STATE OF NORTH CAROLINA  
DEPARTMENT OF TRANSPORTATION

March 24, 2023

**Subject: Request for Modification to Individual Section 404 Permit and Section 401 Water Quality Certification** for recently modified U-2579 AA (USACE, dated February 10, 2021; WQC Rev. 7, dated February 9, 2021), the Winston-Salem Northern Beltway (Eastern Section of Future I-74), from US 311 to I-40; U-2579AA; Federal Aid Project No. NHF-0918(14), Division 9. Debit \$570 from WBS No. 34839.1.7

**T.I.P. No: U-2579AA**

Jurisdictional Stream Crossing at Borrow Site –L- 13+50 LT

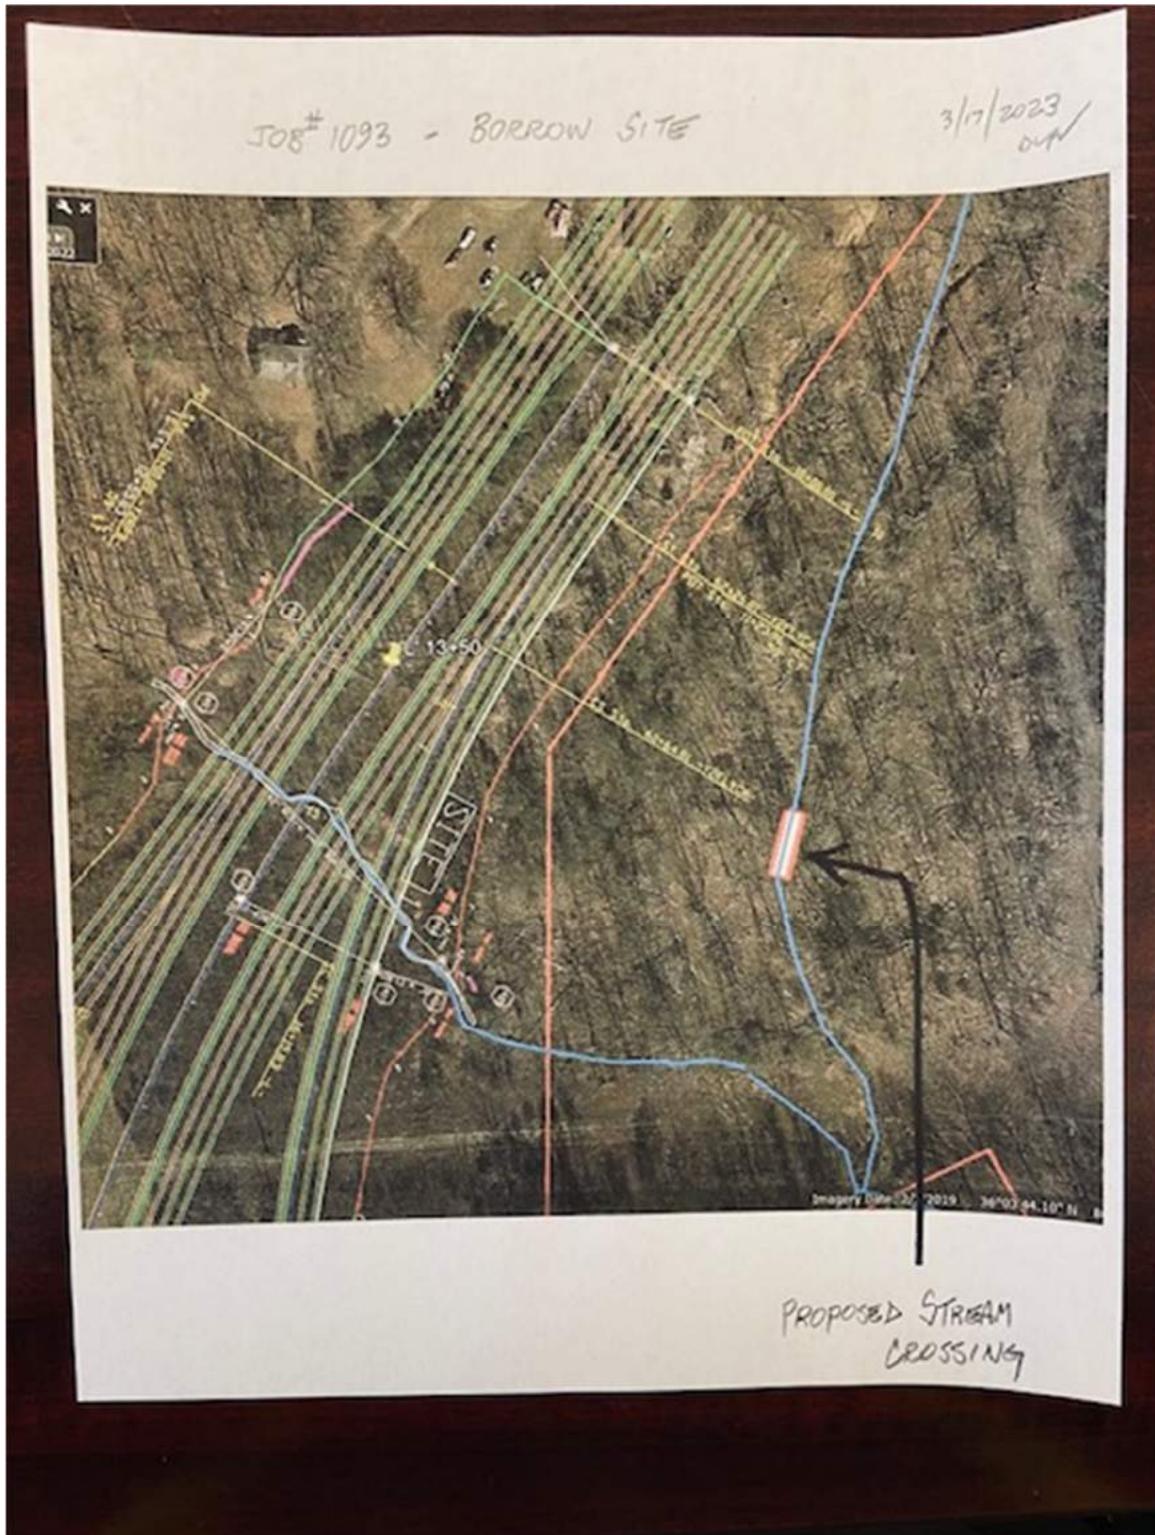
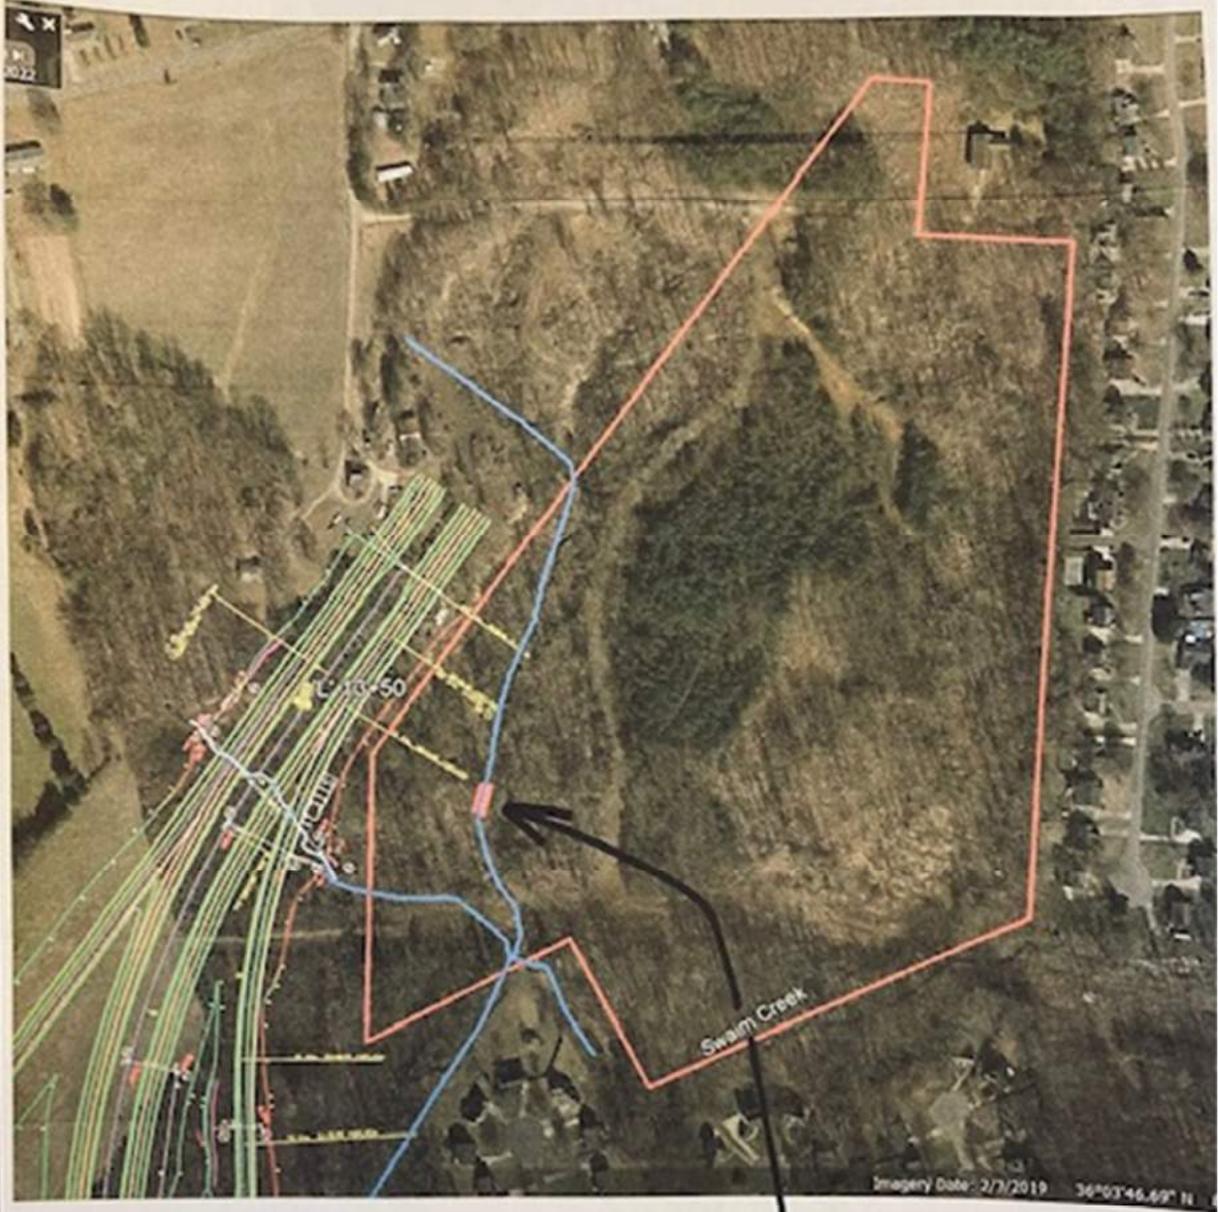
The proposed jurisdictional stream (JS) crossing is located just east of the proposed L alignment at 13+50 LT. The proposed crossing will consist of (1) 42" steel culvert pipes that have a length of 40'. The culvert pipe is a larger size of the proposed 36" culvert pipe (Adjacent Project) upstream of this location. The total impacted length along the JS will be 100' (approximately 30' beyond the inlet and outlet of the 40' culvert pipe).

PERMIT DRAWING  
SHEET 8 OF 32

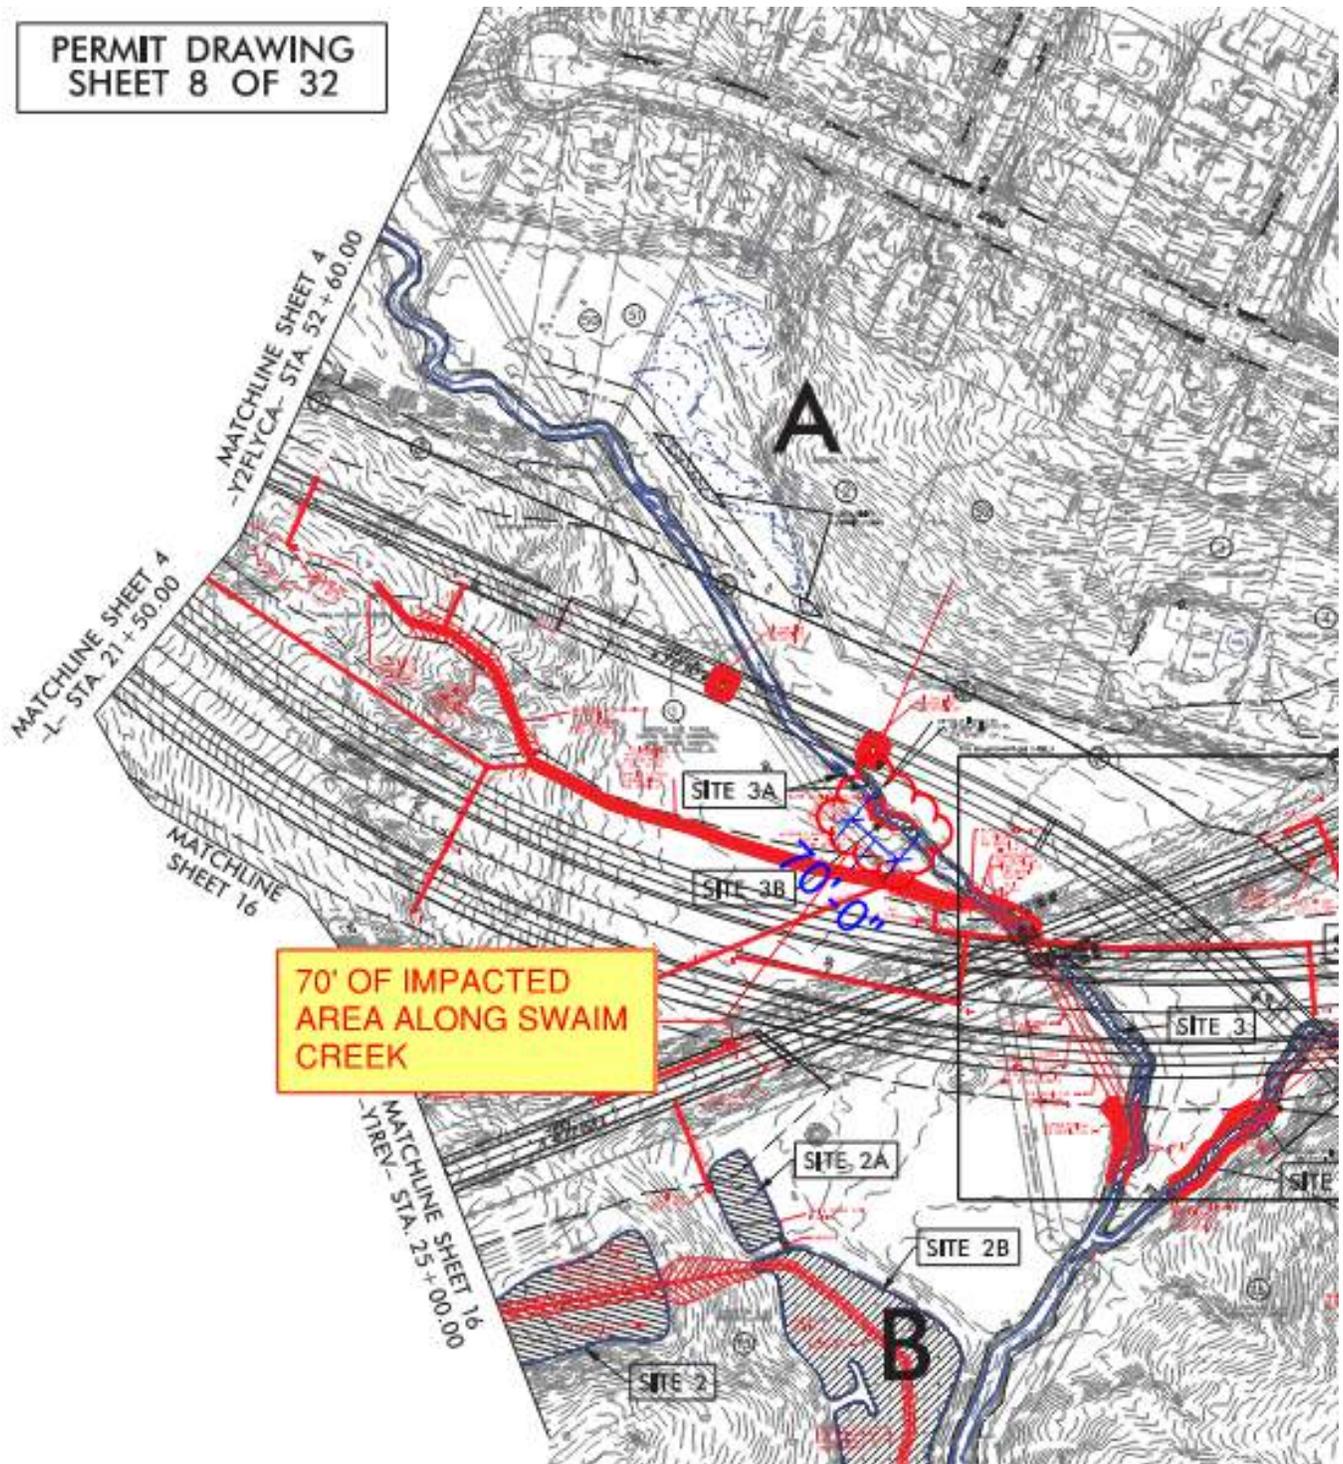
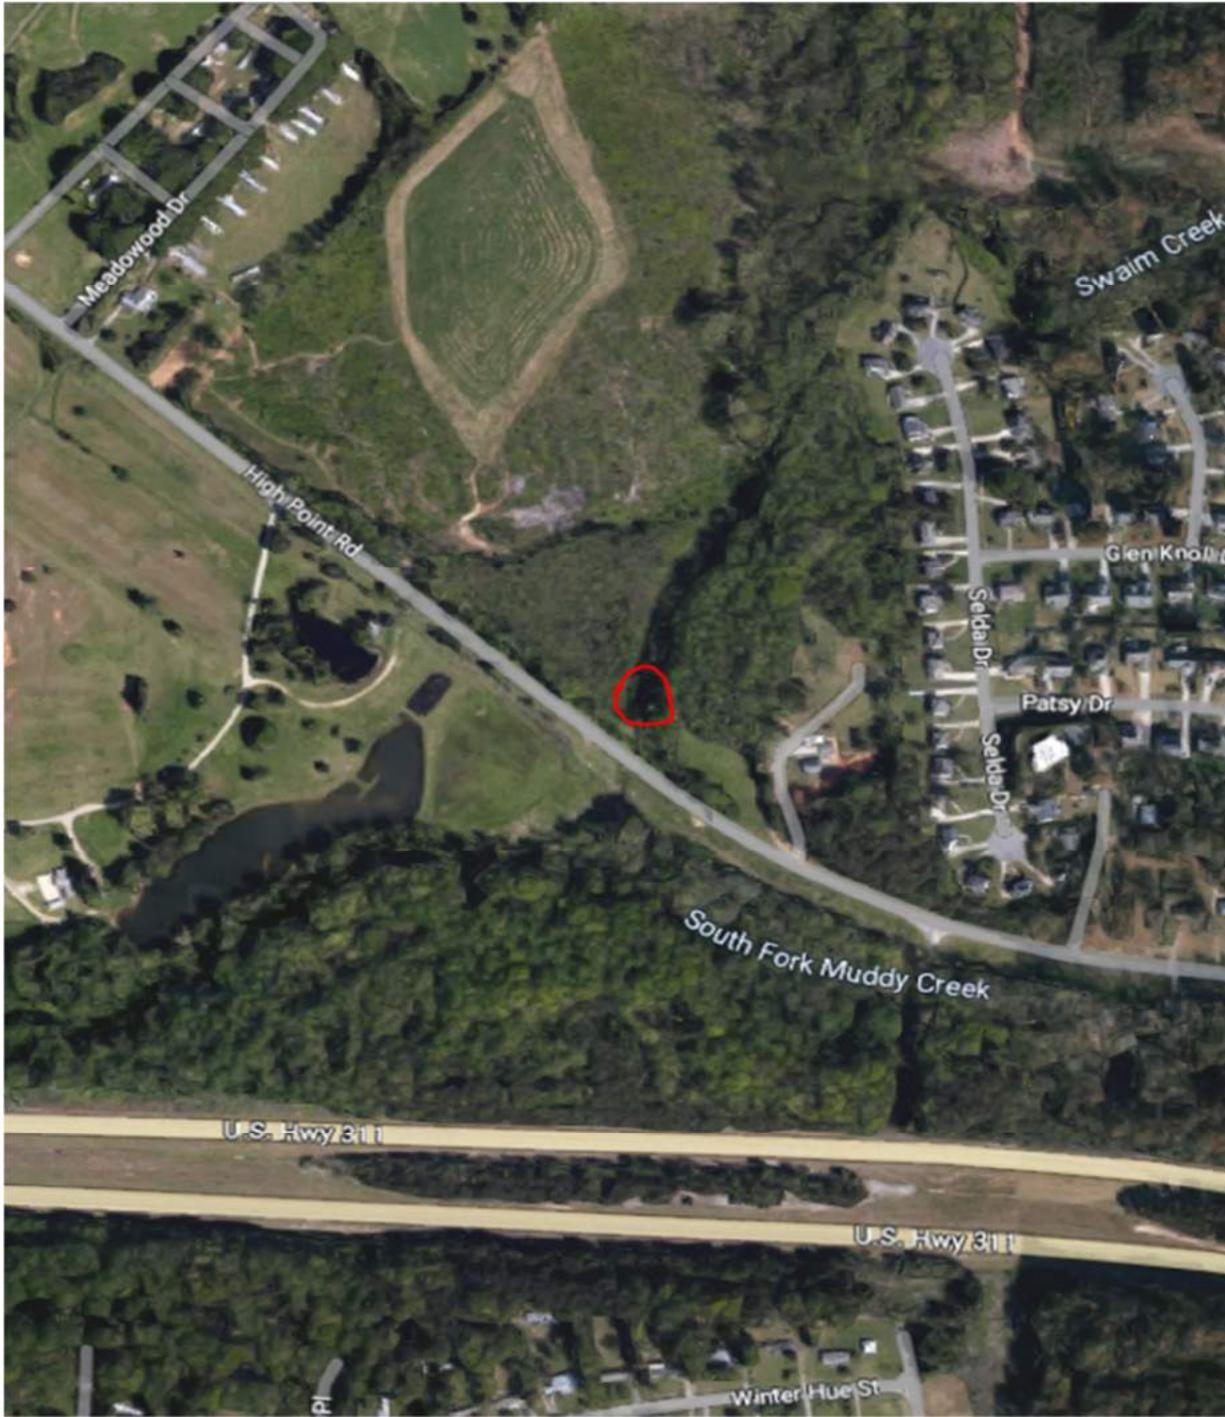
Permit site 3b: The existing impacts at permit site 3b were for the construction of a temporary detour of High Point Road. The contractor has modified the construction plan and no longer needs to construct the High Point Road detour. A bridge was proposed at this location and the impacts were proposed as bank stabilization along the stream under the bridge. The contractor has proposed to utilize the area as a temporary crossing for access. The proposed crossing will consist of (8) 24" steel culvert pipes that have a length of 40'. The (8) pipes will be stacked 2 rows high with (4) pipes in each row. This crossing has been sized for the 2 year storm event which is consistent with NCDOT guidelines for temporary crossings. We previously permitted 35 feet of permanent bank stabilization and 18 feet of temporary impacts at site 3B. We need to permit an additional 17' of temporary impacts at the site. Total impacts will be 70' at site 3b. The existing stream at this location has been field surveyed, so it can be restored in its existing location. Any impacted stream banks will be sloped at 2:1 or flatter, matted with coir fiber matting, and revegetated with native riparian seed mix.

The proposed crossing at Swaim Creek is located just north of High Point Road upstream of the proposed culvert 1 (Station 32+77.5) at permit Site 3B. The proposed crossing will consist of (8) 24" steel culvert pipes that have a length of 40'. The (8) pipes will be stacked 2 rows high with (4) pipes in each row. The same proposed configuration that is being installed for the culvert diversion channel that was already hydraulically approved for access while constructing culvert 1. The total impacted length along Swaim Creek will be 70' (approximately 15' beyond the inlet and outlet of the 40' culvert pipe).
